LiDAR Quality Assessment Report

SD_Missouri River Lidar Dewberry_2016_D16 - Block 4

NGTOC
2018-06-13
Sarah Klaas

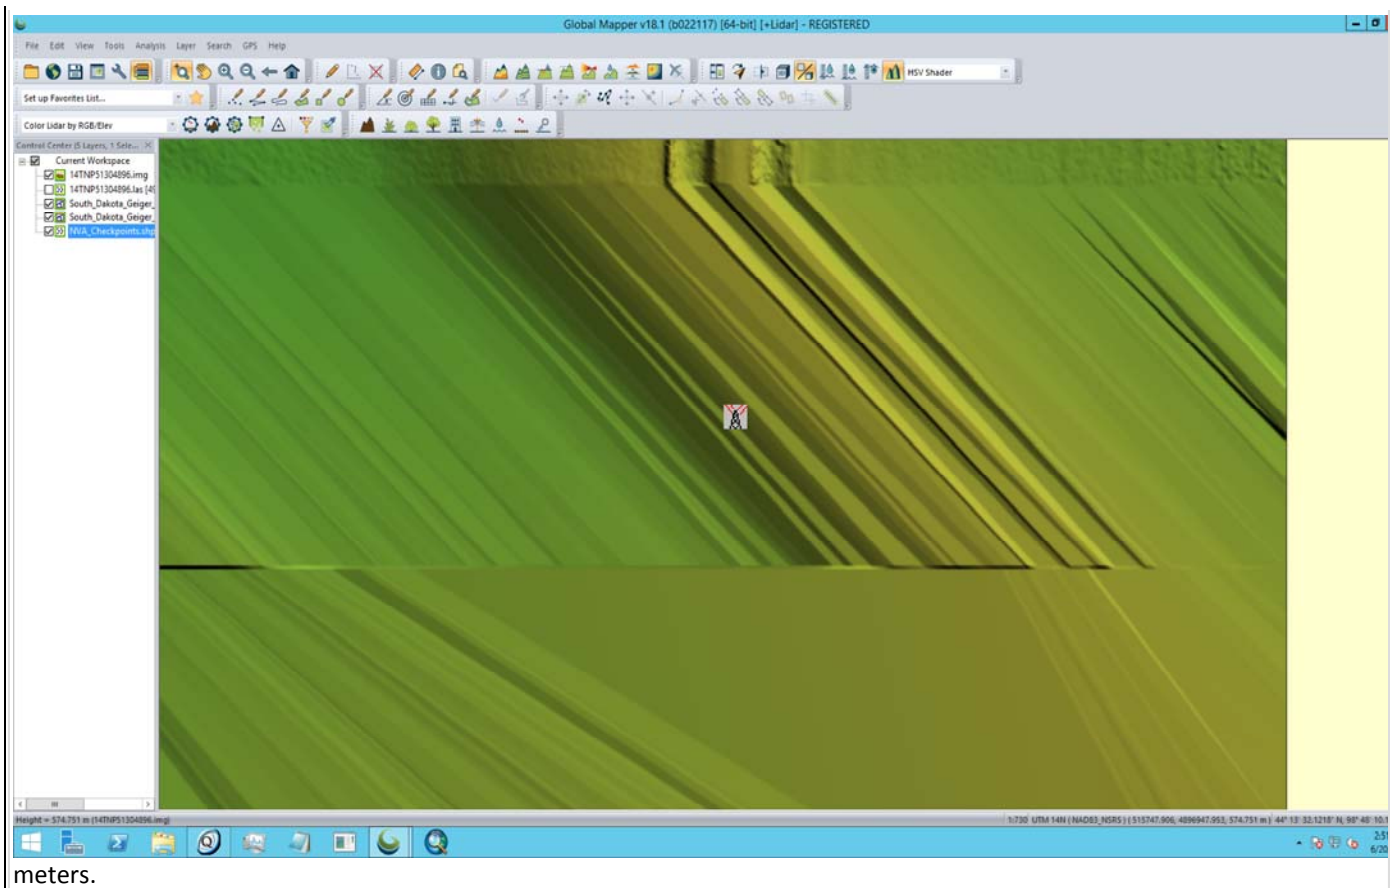
VVA testing failed to meet USGS specifications. Three of the worst points are pictured below, showing the checkpoint below the ground surface.

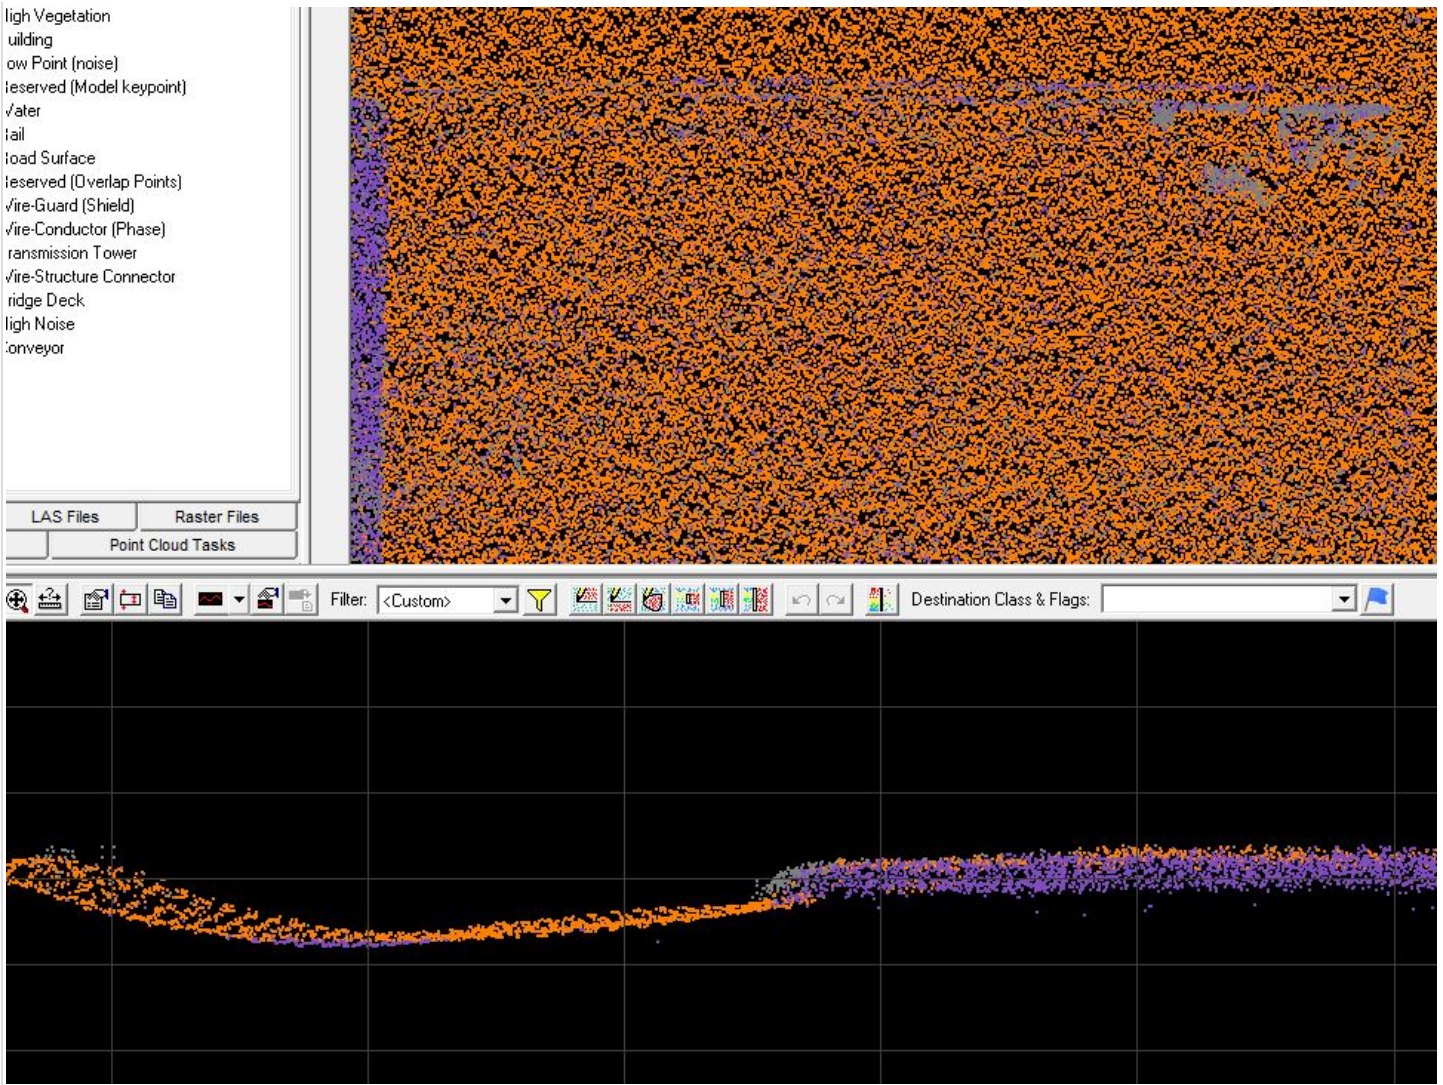
Possible classification issue: ground and low noise points in areas where there could be vegetation in fields. It is not certain that the ground points are actual ground. (6/13/2018)

Not Corrected (9/20/2018)

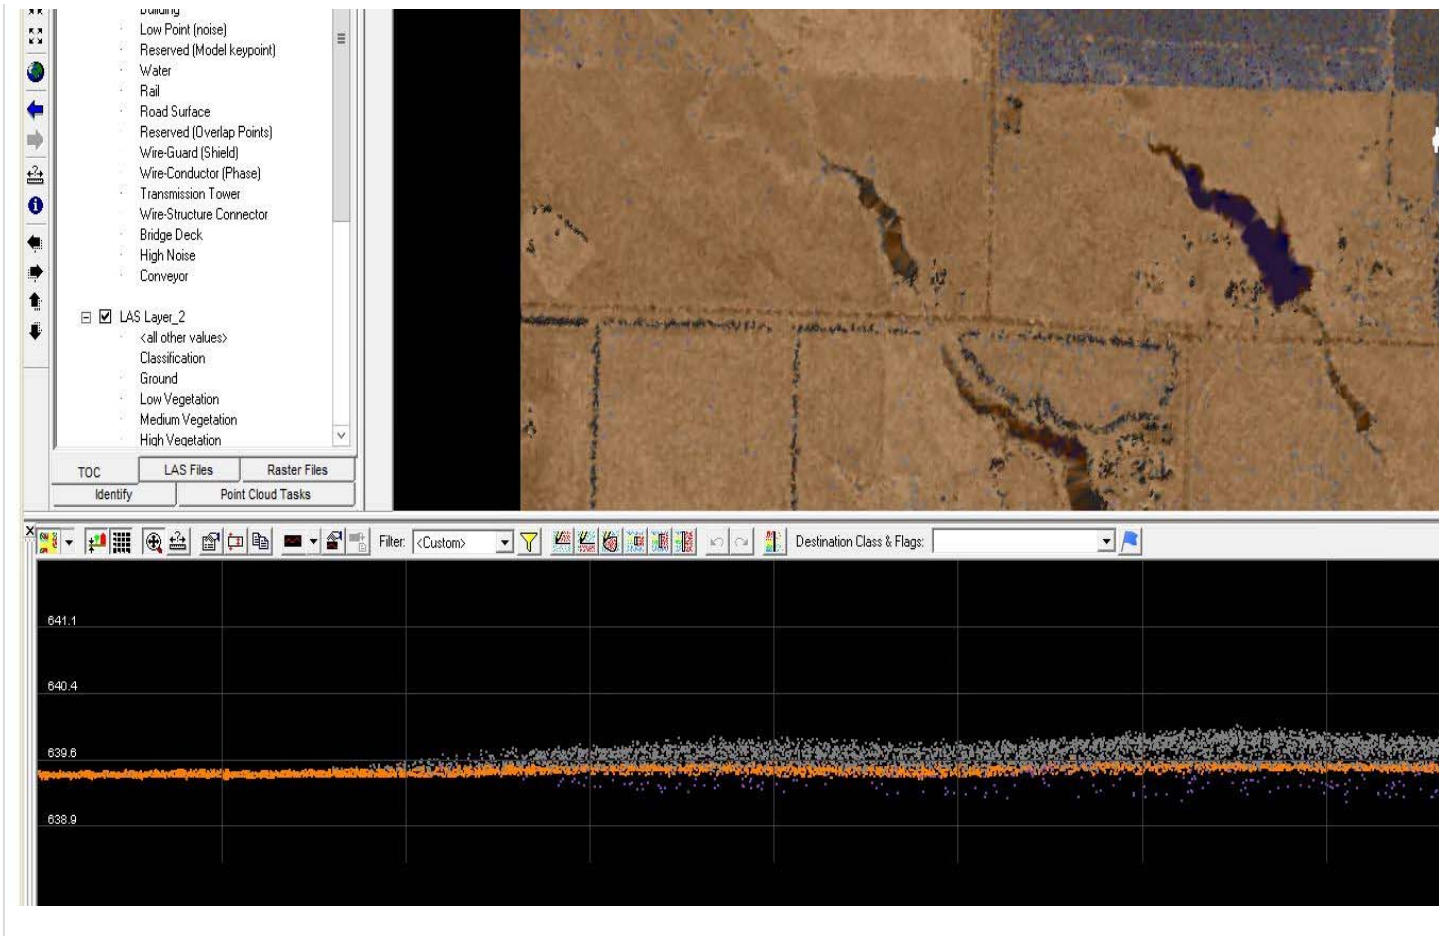
Example of a similar area in another block where the classification of the ground points looks correct.

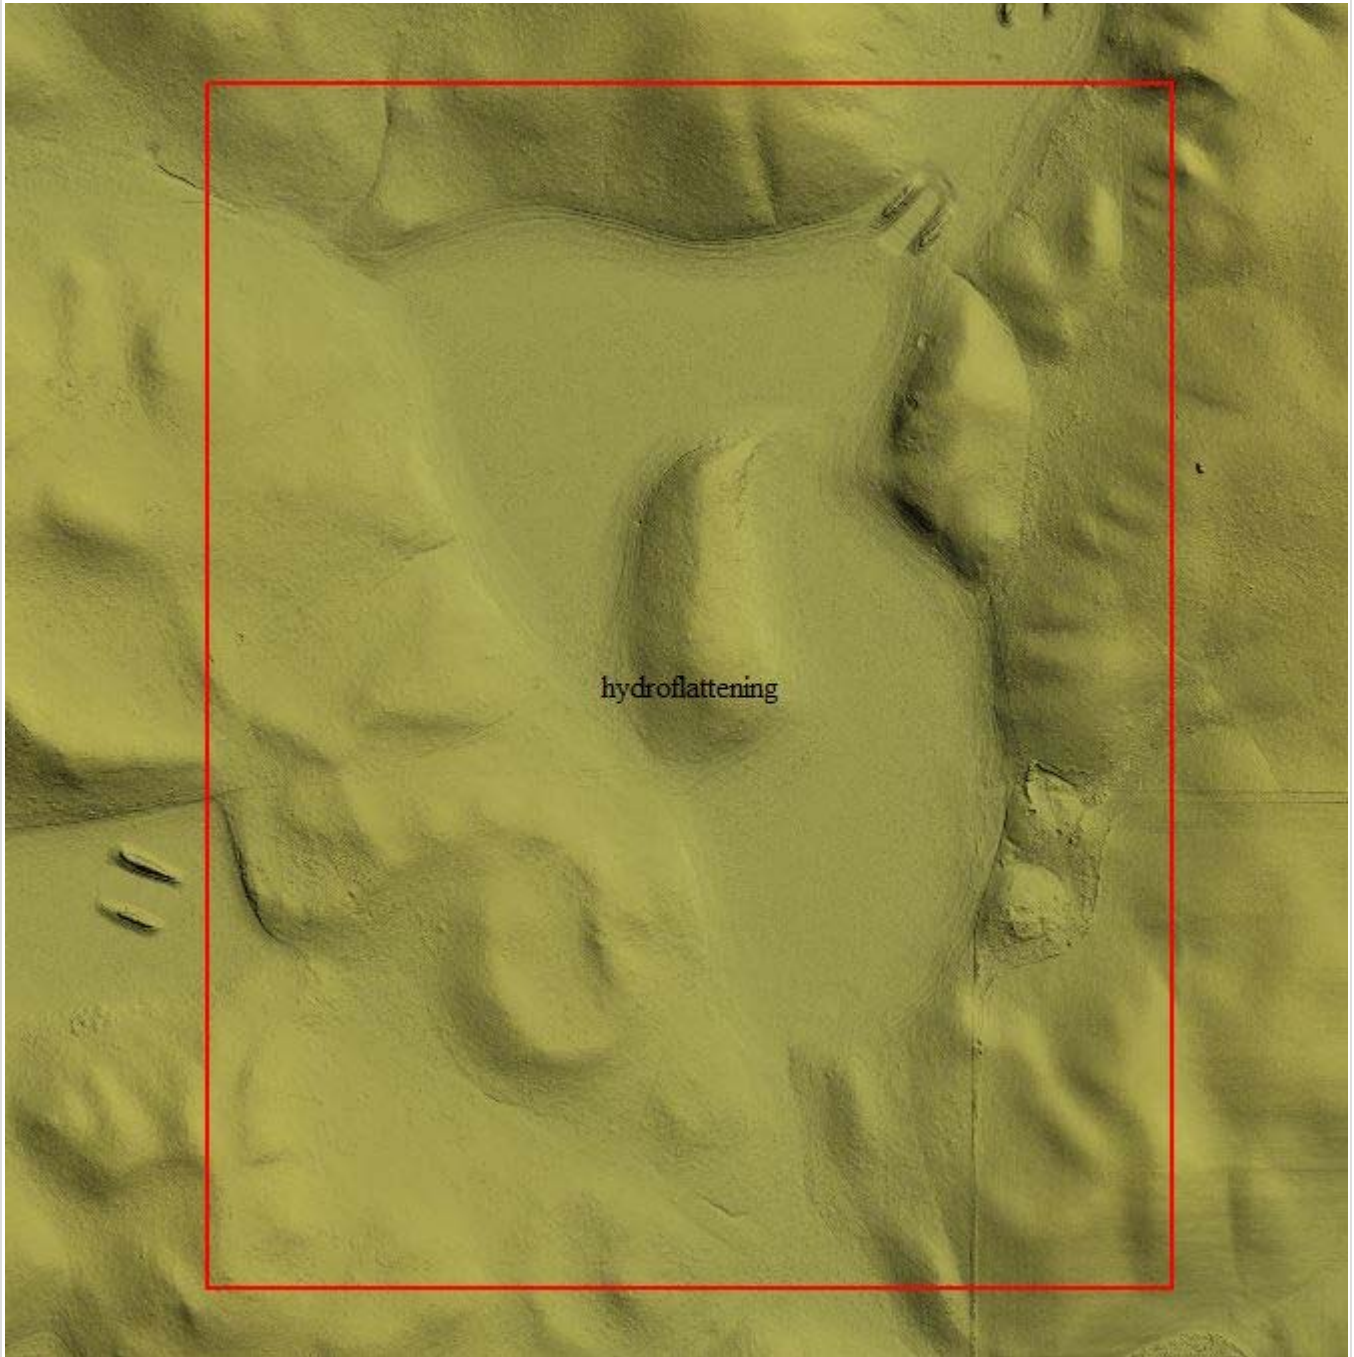
Data does not extend out to the project boundary along the entire East and West extents of Block 4. (6/13/2018)

Dewberry states the data does extend to the project boundary but USGS was not delivered this boundary shapefile and can only judge based on the delivery block diagram shapefile that was delivered. Please deliver the project boundary shapefile that was used to create your data boundaries. (9/20/2018)

Project Boundary was downloaded from PTS. Data delivered cover this AOI.

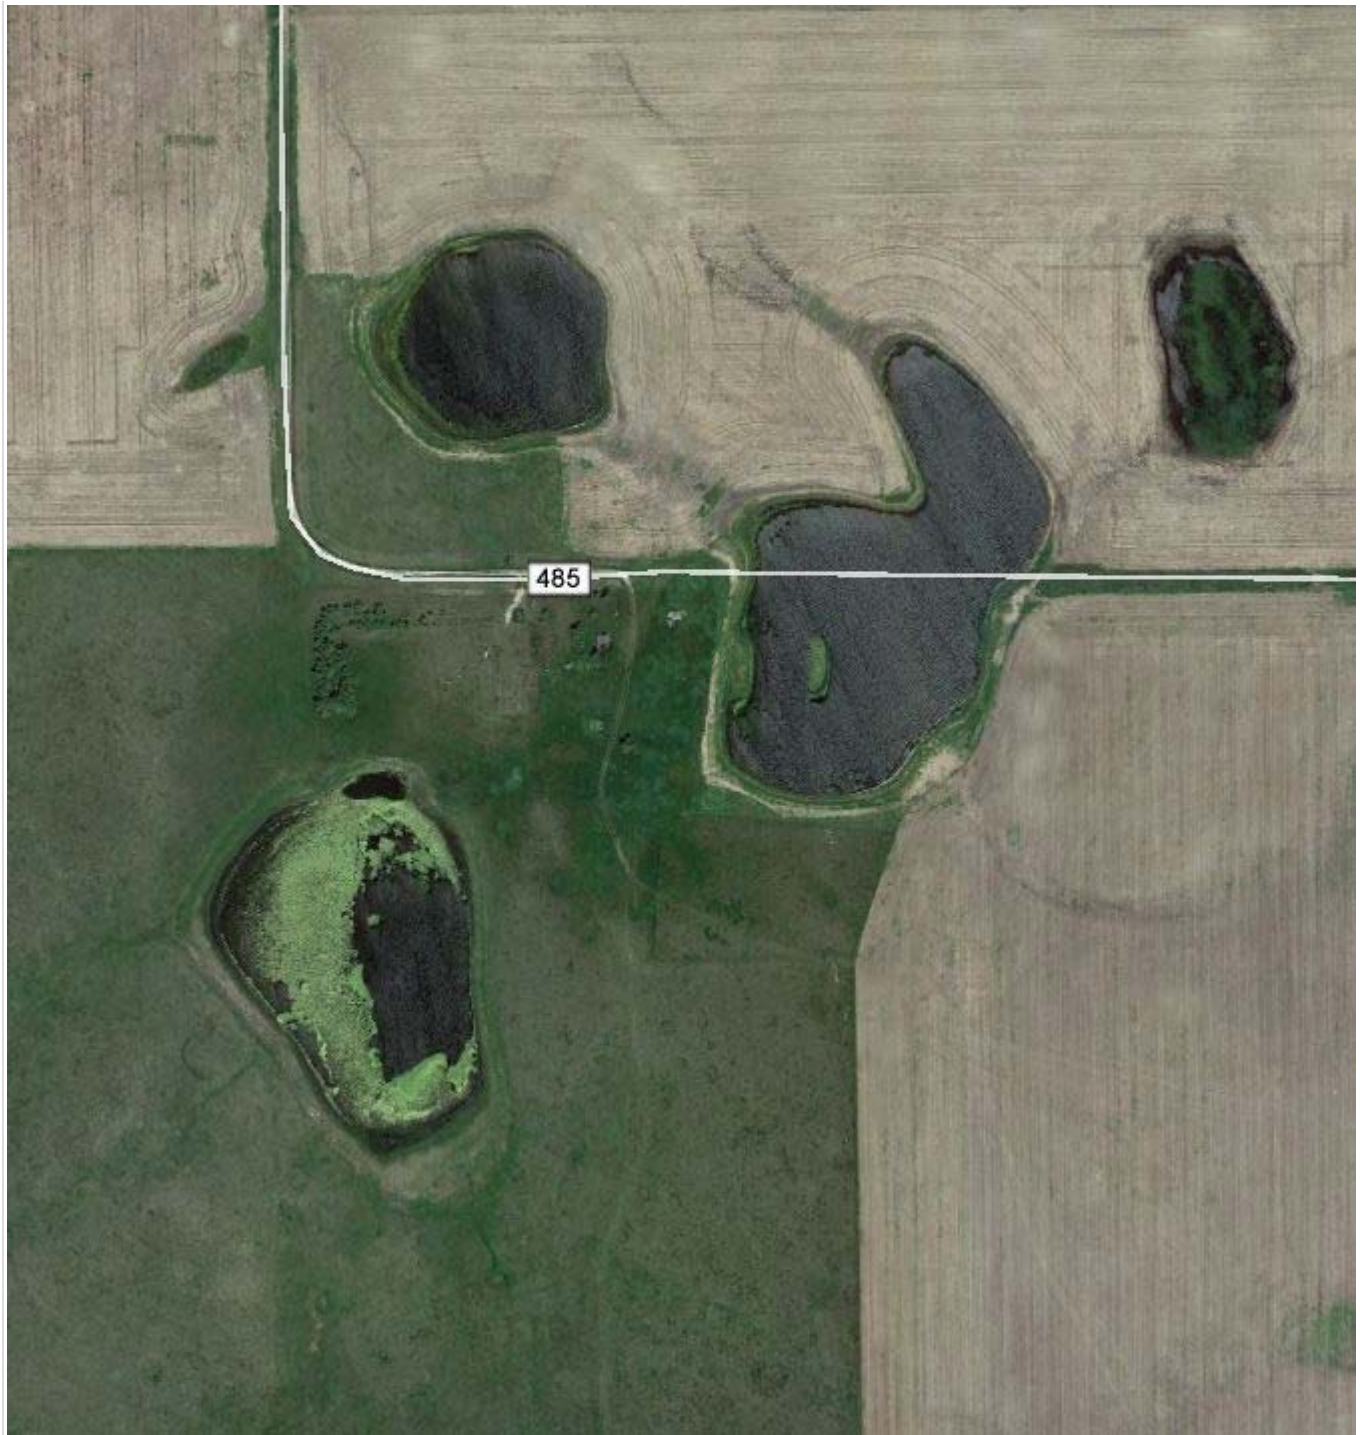
7 hydroflattening errors were found in block 4, waterbodies greater than 2 acres are not hydroflattened. Examples of this type of error can be seen below. (6/13/18)

Corrected (9/20/2018)

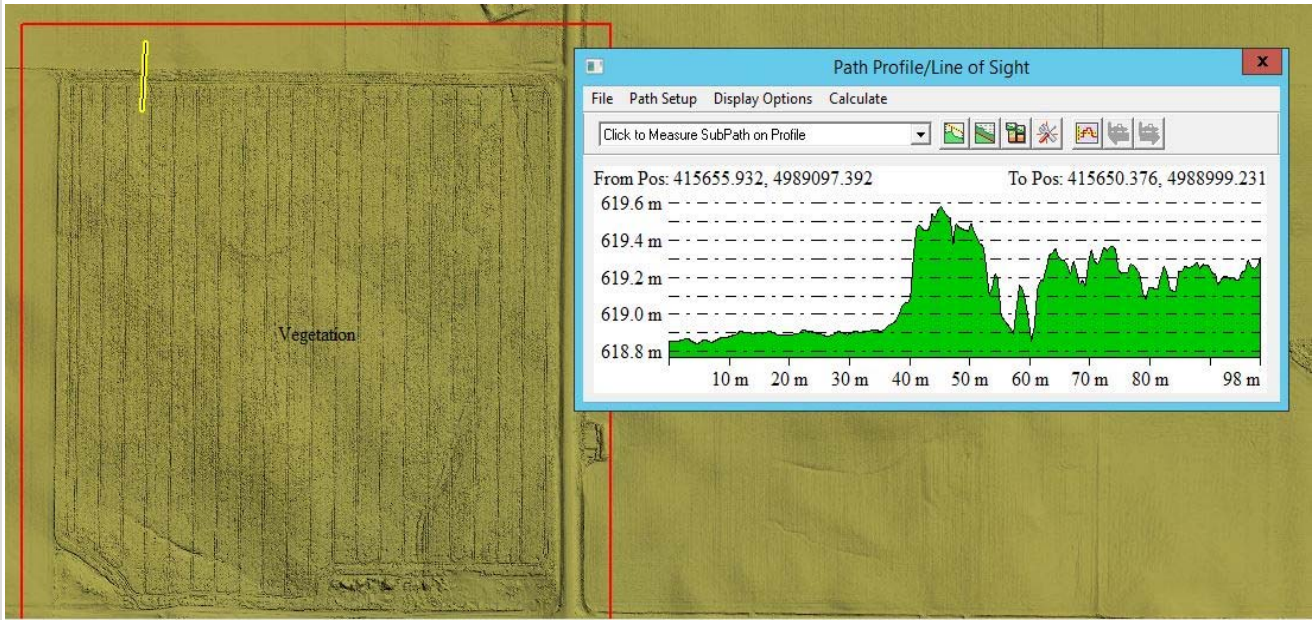
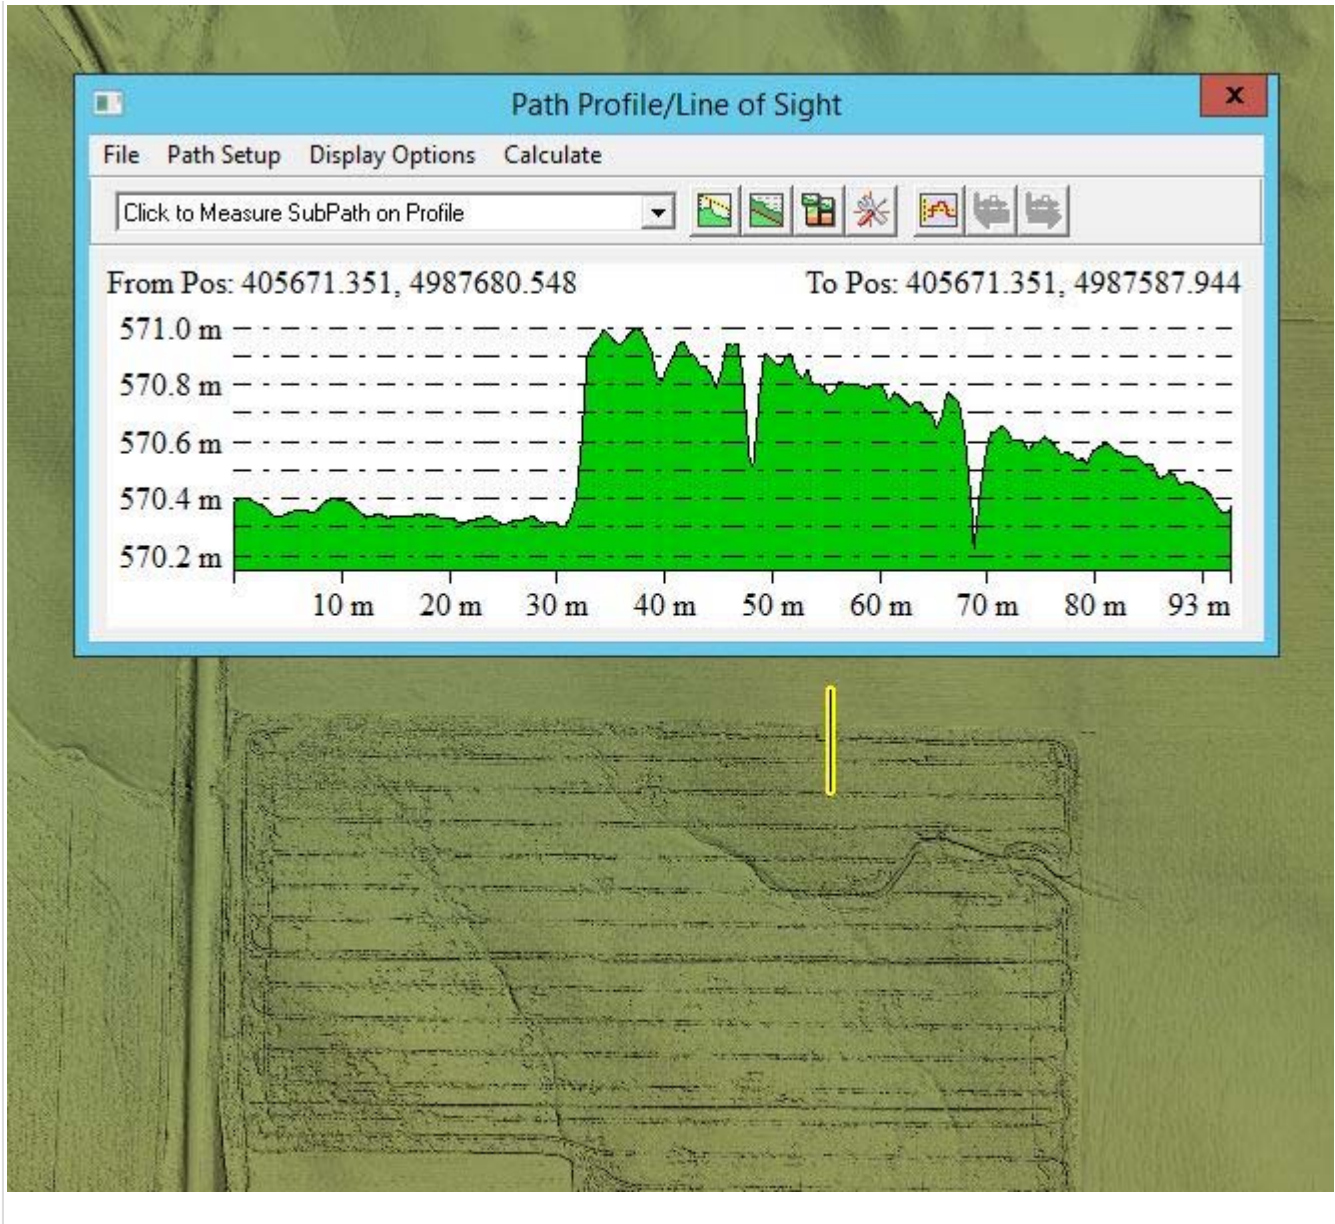
3 errors related to 1 meter tall vegetation in the DEM were found in Block 4, examples can be seen

below. (6/13/2018) **Not Corrected (9/20/2018)**
